Date: November 6, 2007
To: T10 Technical Committee
From: Alvin Cox (alvin.cox@seagate.com)
Subject: SAS-2 6Gbps PHY Electrical Specification

Abstract: The attached information defines the electrical requirements for 6 Gbps transmitter devices and receiver device. In addition, updates include reference transmitter and receiver device definitions to provide a means of determining if a channel is compliant and a cable specification section with requirements for 6Gbps usage. This proposal is a continuation of 07-063, at it ran out of revisions available.

Figure xxx —6Gbps RTTL physical characterization

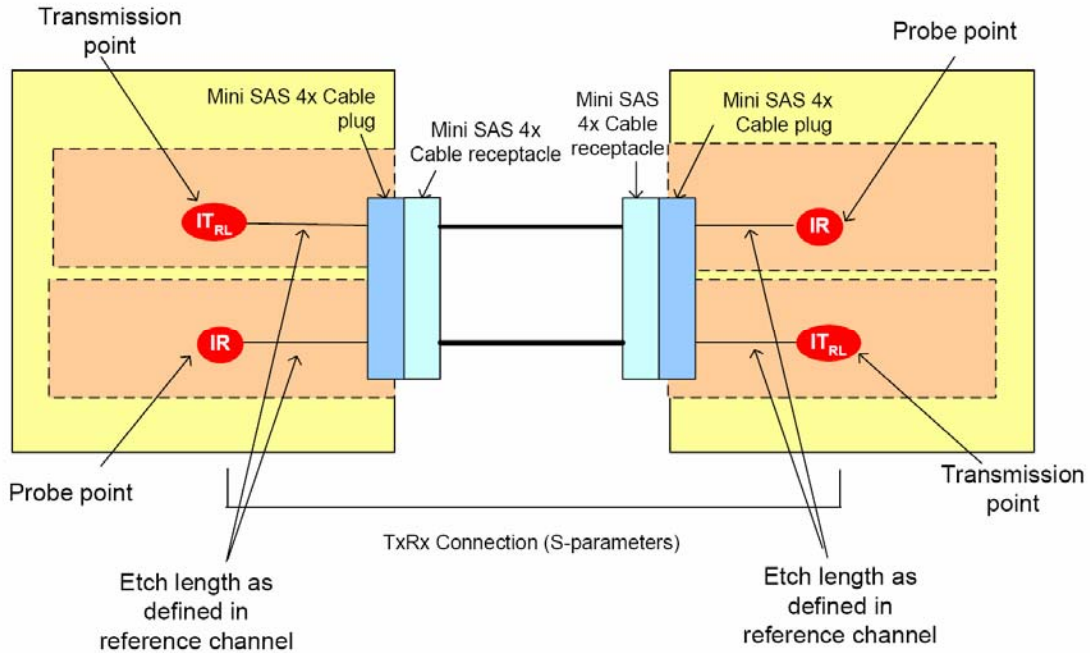
For 6 Gbps simulation testing, the reference transmitter test load (RTTL) is described by the S-Parameter (S4P, Touchstone format) model available from the T10 web site, proposal 07-193, SAS 2.0 Transmitter Test Load. The physical model used to measure the RTTL is illustrated in

Figure xxx. The etches between the transmission points and probe points are typically included in any TxRx connection S-Parameter measurement and the specific etch configuration for the RTTL is defined in the SAS 2.0 Transmitter Test Load documentation. Although these etches add extra loss to the TxRx connection, they are considered to be an acceptable amount of loss for simulation purposes when restricted to a configuration similar to the RTTL.

Figure 118 — Transmitter device common mode voltage limit

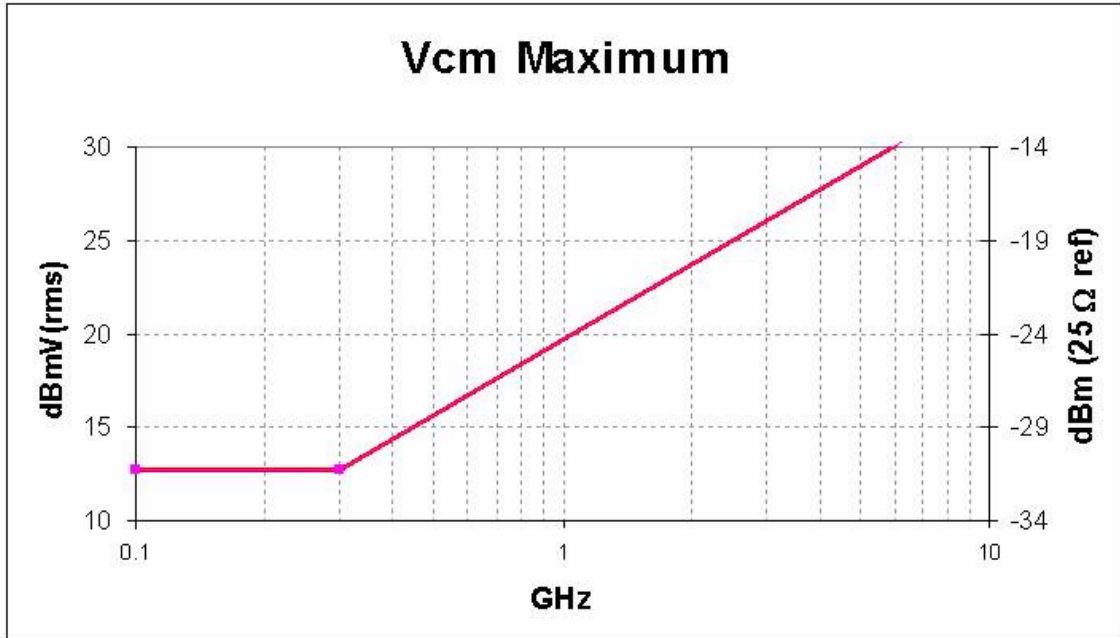
i The transmitter device common mode voltage shall be measured with a 1 MHz resolution bandwidth through the range of 100 MHz to 6 GHz with the transmitter device output of CJTPAT. The end points of the range shall be at the center of the measurement bandwidth.

Figure 122 — Transmitter equalization measurement

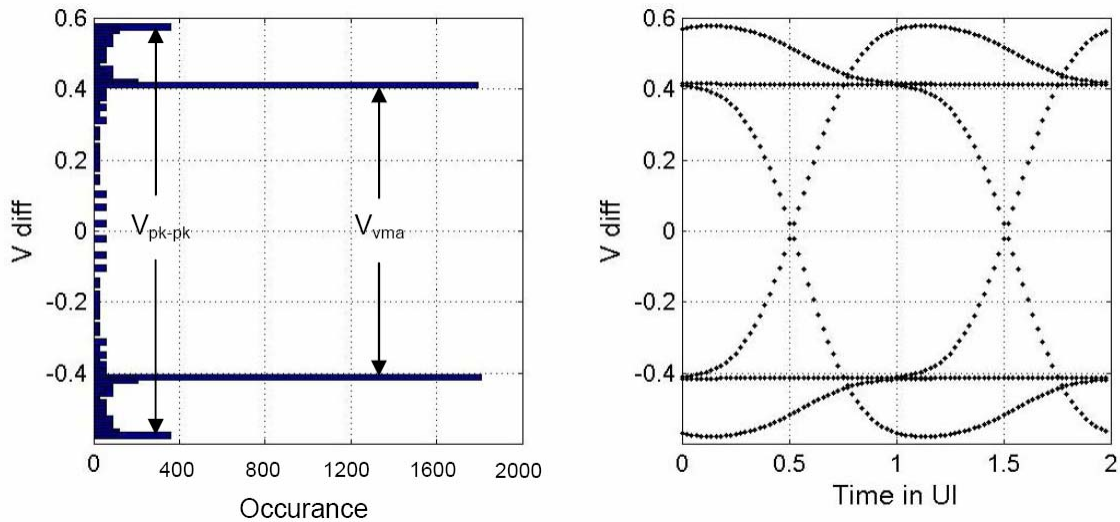
- c. The V_{vma} mode value and V_{pk-pk} peak value shall be determined as illustrated in Figure 122. A sample size of 1000 minimum, 2000 maximum histogram hits for V_{vma} shall be used to determine the values. The histogram in the figure is a combination of two histograms, an upper histogram for TX+ and lower histogram for TX-. (The histograms on the left of the test pattern signal displayed on the right.) The V_{vma} mode value and V_{pk-pk} peak value are determined by adding the values measured for TX+ and TX-.
